UNITED STATES
NUCLEAR REGULATORY COMMISSION
REGION I
631 PARK AVENUE
KING OF PRUSSIA, PENNSYLVANIA 19406

Subject: Inspection 70-687/78-02

Subj: Inspection 70-687/78-02

Subj: PROPOSED AMENDMENT TO SPECIAL NUCLEAR MATERIAL
(SNM) LICENSE No. 639.

FIGURE 1

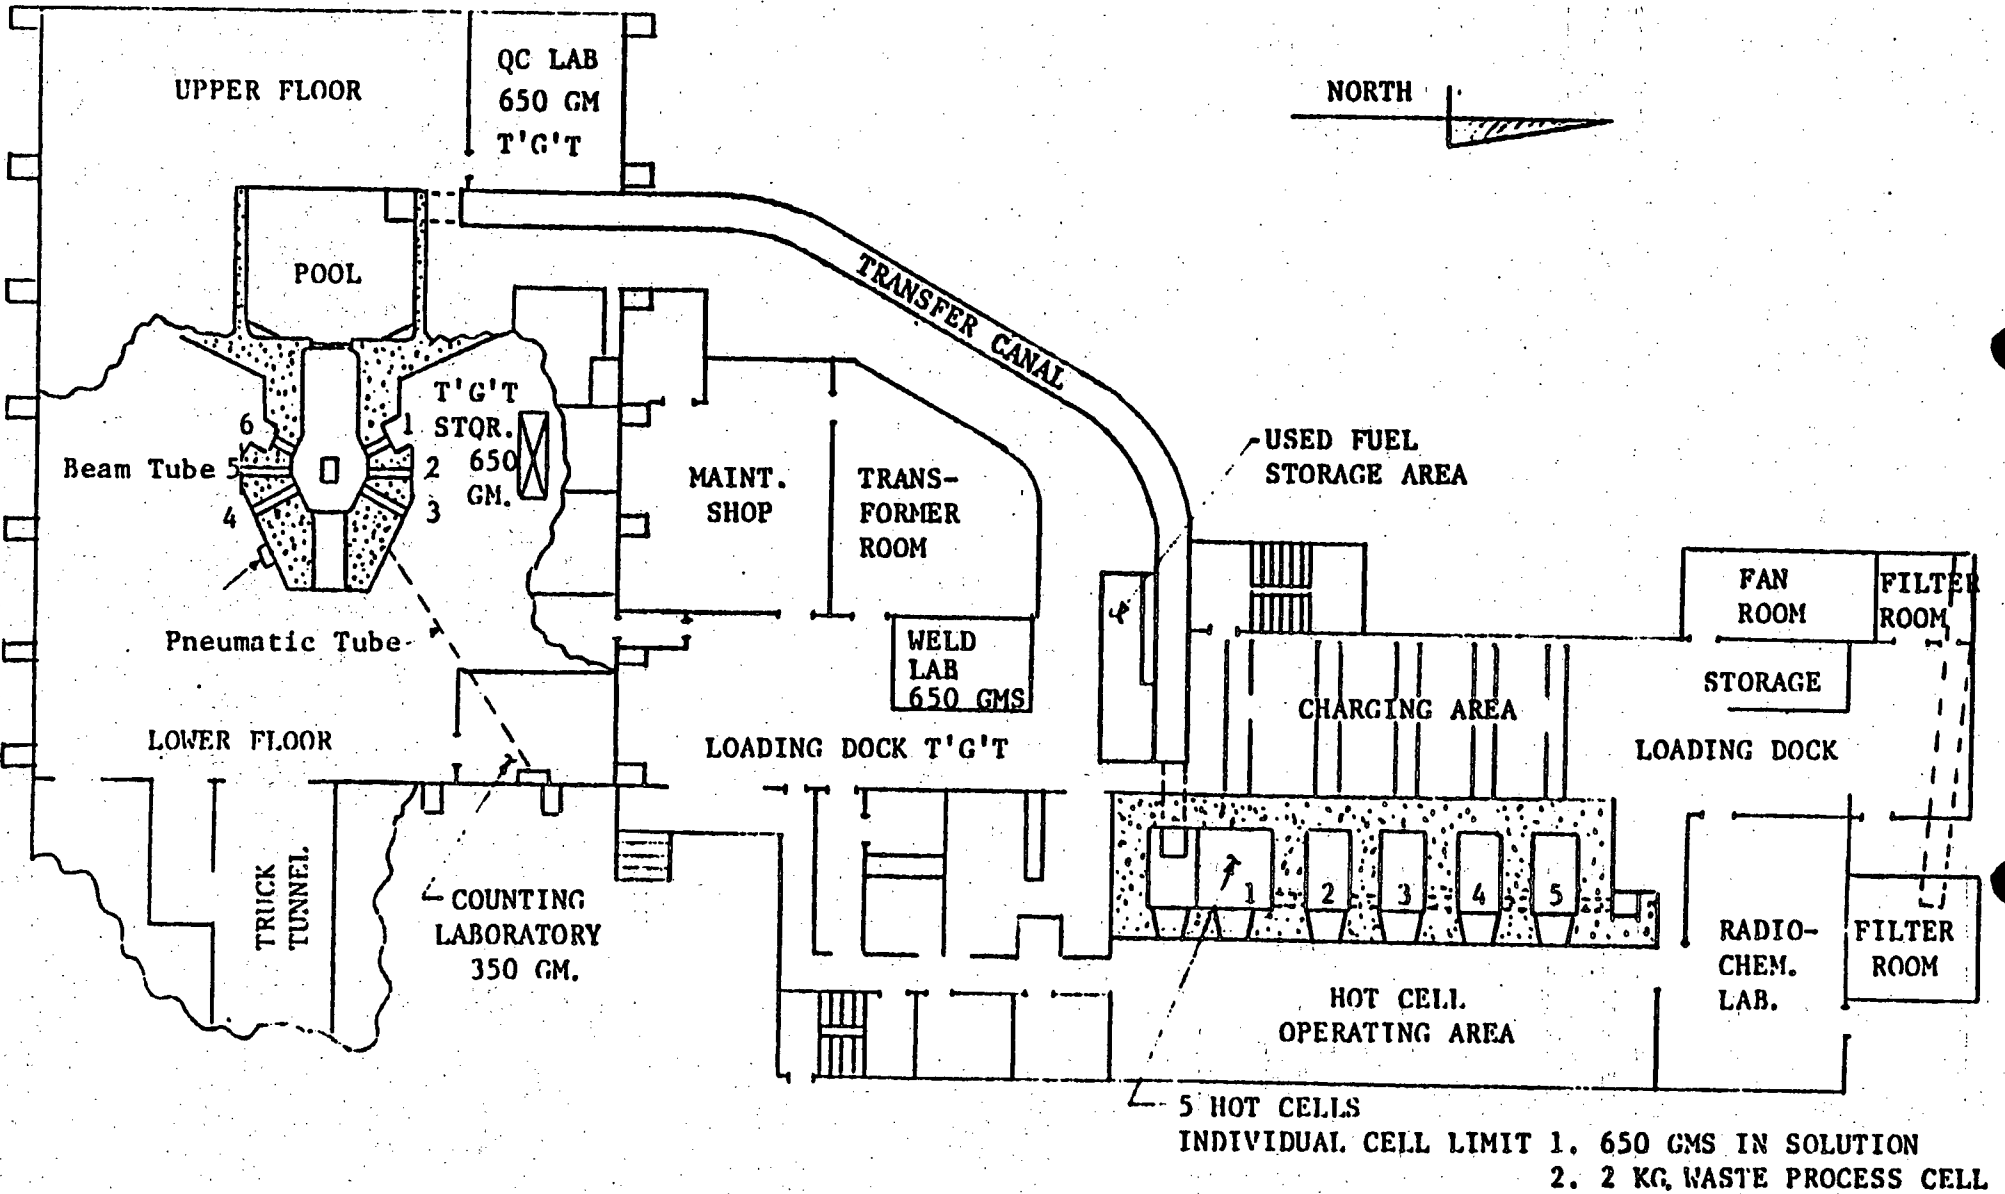
Revised floor plans are included to reflect the current storage locations and processing laboratories. A check in the amount of \$150.00 is enclosed to cover the administrative fee requirements of 10 CFR 170.31.

FIGURE 1A

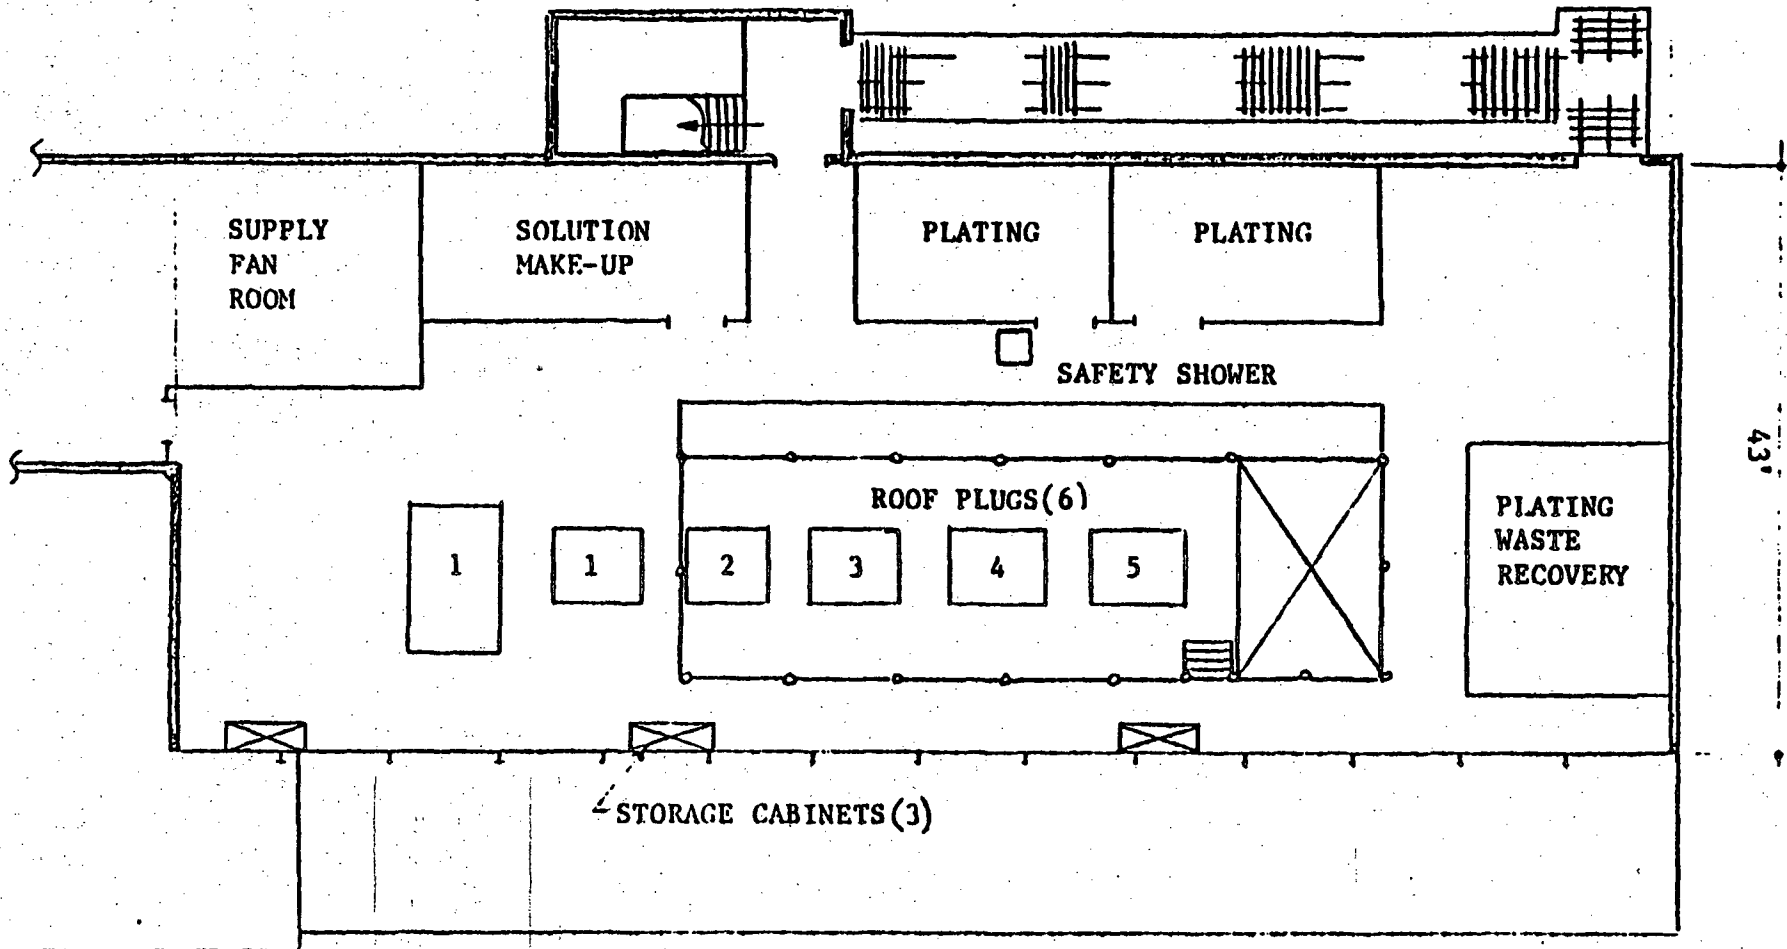
Uranium is stored in storage cabinets in the upper level of the hot laboratory (Fig. 1A). Material in liquid form is doubly contained. Storage cabinets are of fireproof construction, are separated by a minimum distance of three feet and are fastened to prevent inadvertent movement. All cabinets are locked and keys are in the custody of the SNM custodian for the area. Criticality control is implemented by limiting the quantity of SNM in solution to 350 grams per storage cabinet. This limit allows a safe margin below the single parameter limit of 760 grams U-235 in uniform aqueous solutions specified in the ANSI N16.1-1969 standard even

"A.4. SNM, as an oxide, encapsulated for irradiation shall not exceed 650 grams in a single laboratory. When SNM is in process in the plating lab (Fig. 1A), it can be either as a solid (oxide) or in solution (electrolyte 15 gms/liter, H:U = 1500) and the quantity of either form shall be governed by the formula:
